Re: Objections to Agenda Item No. 3 (Council File 14-0218); Appeal of
Case No. DIR-2012-2836-DB-SPR-CDO and ENV-2012-2837-MND

This office represents GE RealProp, LP, owner of the Wilshire Motel at 12023 Wilshire Blvd., Los Angeles, California. The Wilshire motel is a one-story motor court style motel that is adjacent to, and will be adversely affected by, the proposed Picasso Brentwood Project ("Project") at 12027-12035 Wilshire Blvd. This appeal of Case No DIR-2012-2836-DB-SPR-CDO and ENV-2012-2837-MND is filed on its behalf.

Subject: Proposed Picasso Brentwood Project

EXHIBIT 1

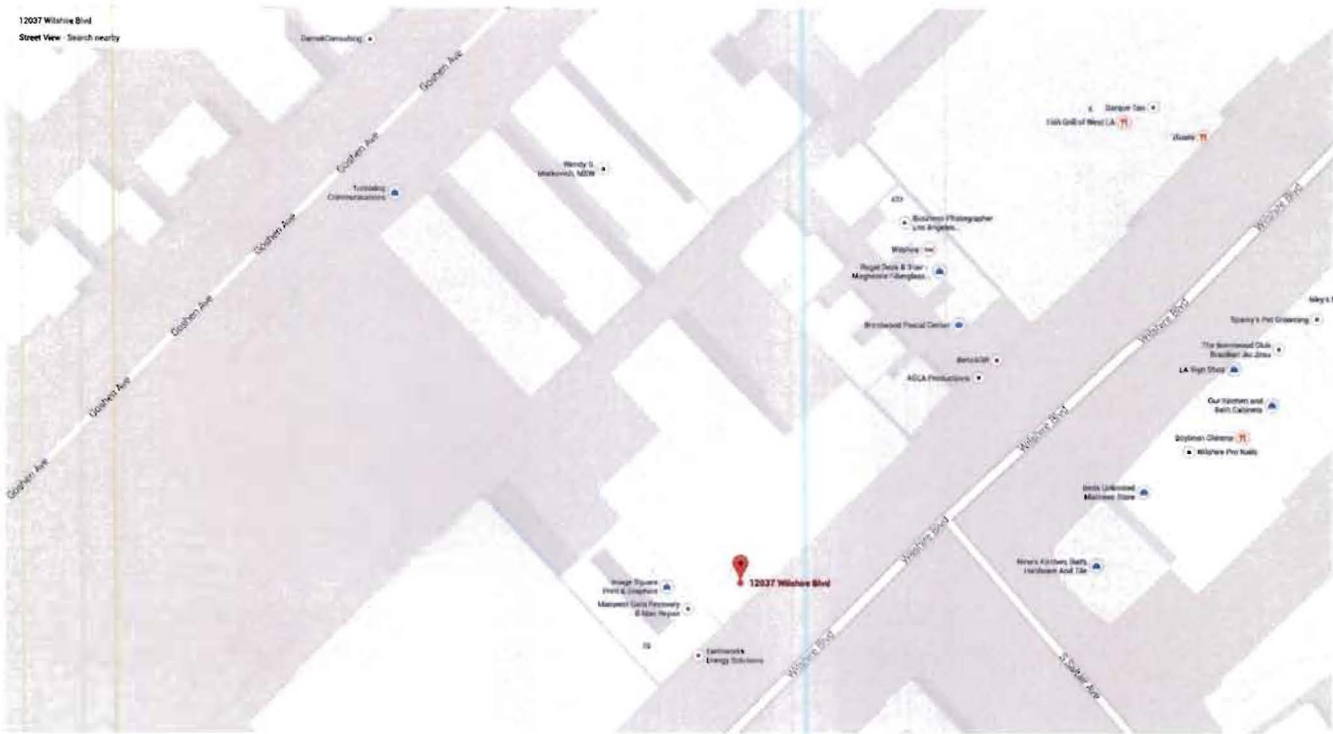
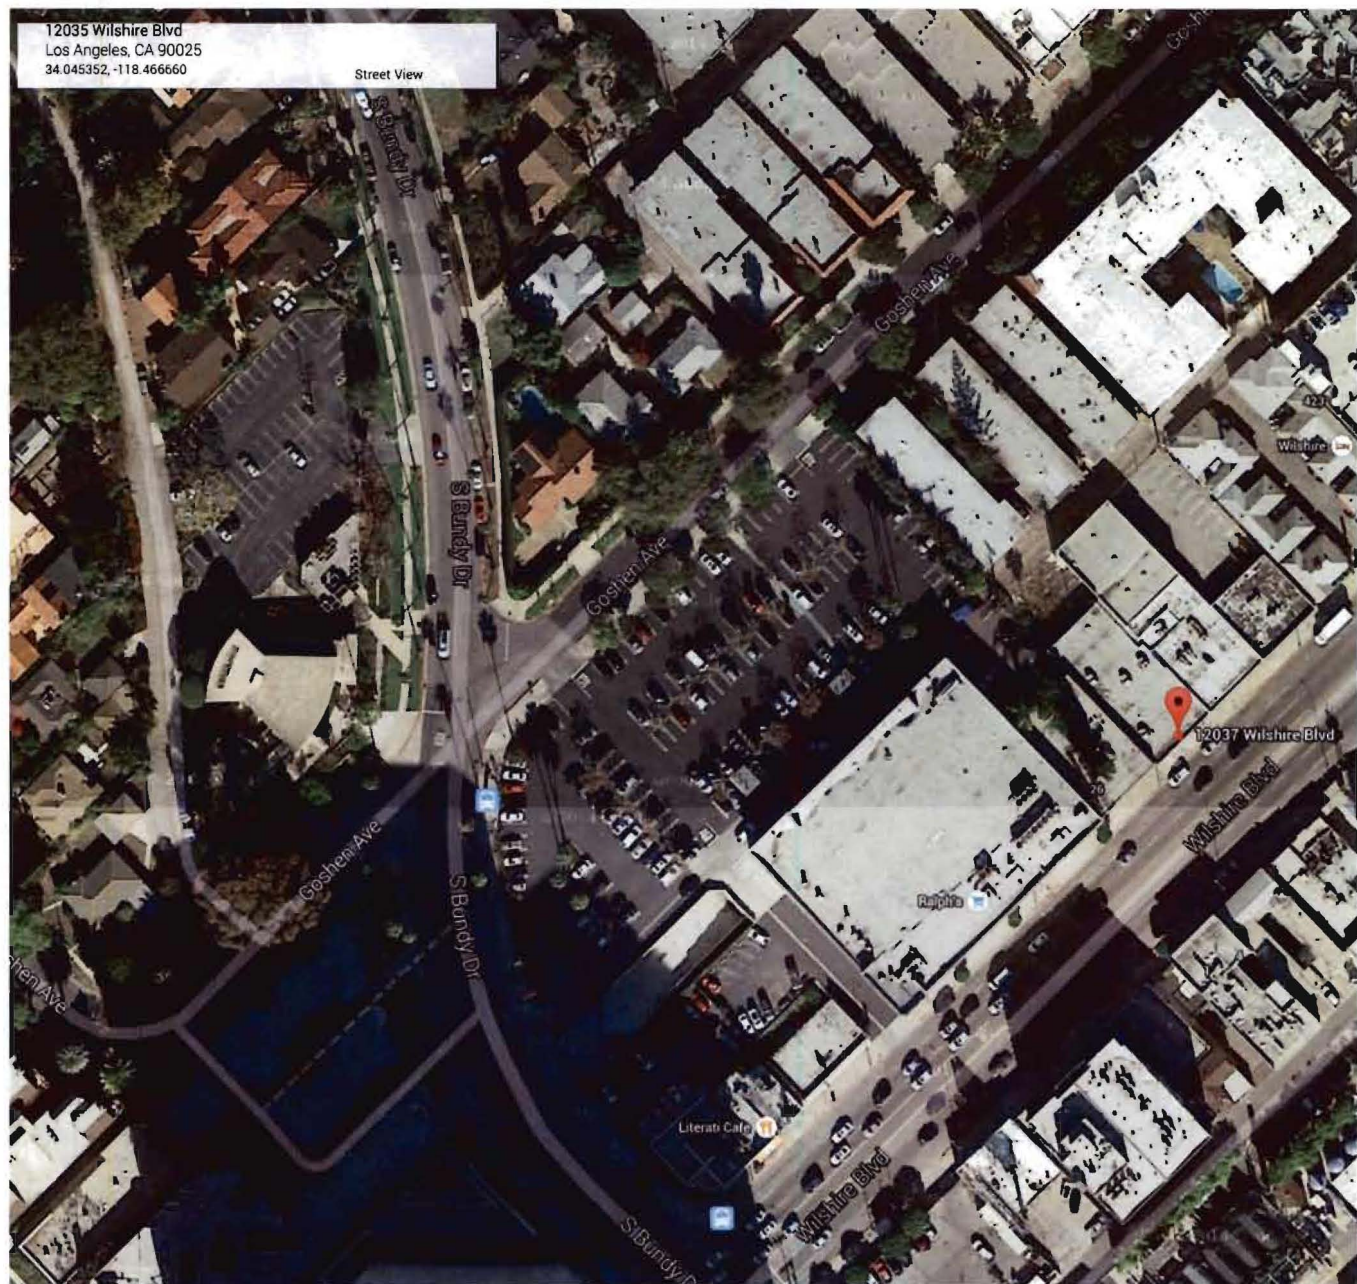
¹ While not in a residential zone, the City and Application have implicitly and explicitly treated the 75 dBA noise limit as a threshold for construction noise impacts near residential uses. The Los Angeles Municipal Code generally treats hotels as the equivalent of a residential use for the purpose of ordinances. See L.A.M.C §41.40(a). There is also property zoned R3-1 directly across the alley, within 500 feet of the Project. Indeed, the alley is only 20-feet wide, placing the buildings directly across the alley much less than 50 feet from the project property line. The maps contained in **Exhibit 1** provide

context as to how narrow the alley is and how close the buildings across the alley are to each other.

erection/finishing noises may still exceed 75dBA at the opposite end of the Project site. That 75dbA noise limit will also be exceeded in the R3-1 zone across the 20-foot alley.
